Project	IEEE 802.16 Broadband Wireless Access Working Group < http://ieee802.org/16 >	
Title	Optional midamble for OFDMA mode	
Date Submitted	2003-03-07	
Source(s)	Yigal Leiba Yossi Segal Zion Hadad Itzik Kitroser RunCom Technologies LTD. Hahoma 2 St., Rishon Lezion, Israel Soon Yoon Young Samsung Electronics Co., Ltd. Suwon, Korea	Voice: 972-3-9528440 Fax: 972-3-9528805 yigall@runcom.co.il yossis@runcom.co.il zionh@runcom.co.il itzikk@runcom.co.il soon.young.yoon@samsung.com
Re:	Call for Comments: Editor's Draft Consolidation of IEEE 802.16/802.16a/802.16c – (802.16d-03/13)	
Abstract	The document suggests addition of an optional midamble to the OFDMA mode of the IEEE802.16a to enhance performance in broadband channels in a mobile environment.	
Purpose	To adopt these enhancements as additions to the OFDMA mode	
Notice	This document has been prepared to assist IEEE 802.16. It is offered as a basis for discussion and is not binding on the contributing individual(s) or organization(s). The material in this document is subject to change in form and content after further study. The contributor(s) reserve(s) the right to add, amend or withdraw material contained herein.

Optional midambl

Figure 1: PMP frame structure example with the optional midamble - TDD

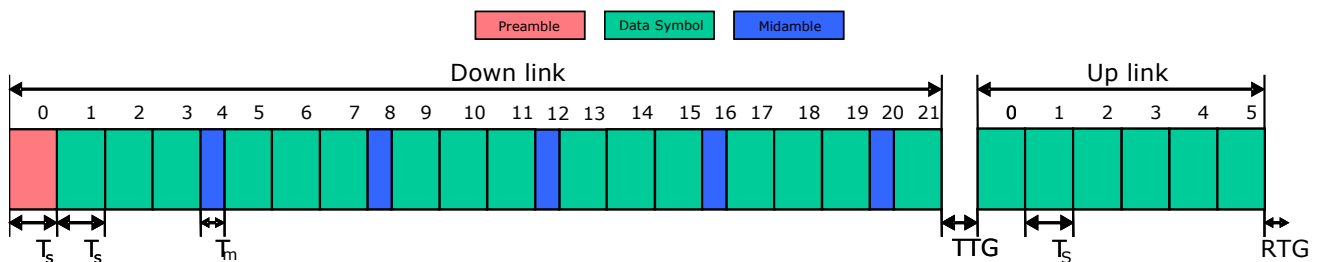
8.5.4.3 PMP frame structure with optional midambles

The basic PMP frame structure described in section 8.5.4.2 can be enhanced for use in broadband channels by use of optional midambles. The midambles are half OFDMA symbol long, and use the same GI as the rest of the OFDMA symbols. The midamble duration is $T_m = (T_s - T_g)/2 + T_g$. The midambles are inserted every third OFDMA symbol not counting the frame preamble.

The midambles presence or is indicated in the DL_FRAME_PREFIX. The preamble is optional in a sense that a BS may support the optional midambels, and an SS may take advantage of its presence, but an SS shall recognize the presence of the midamble and interpret the downlink structure accordingly.

Figure 2: Midamble generation in time domain

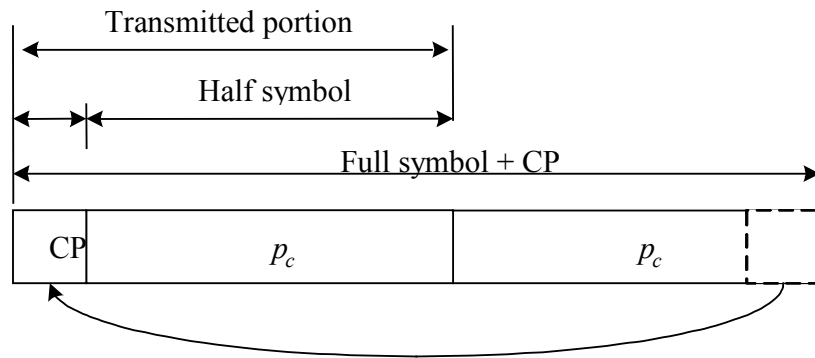
8.5.9.4.4 Pilot modulation for optional midambles

The optional midambles which may be transmitted every three OFDMA symbols in the downlink are half the length of a regular OFDMA symbol, but include a full CP. Figure 2 shows how the midamble is generated.
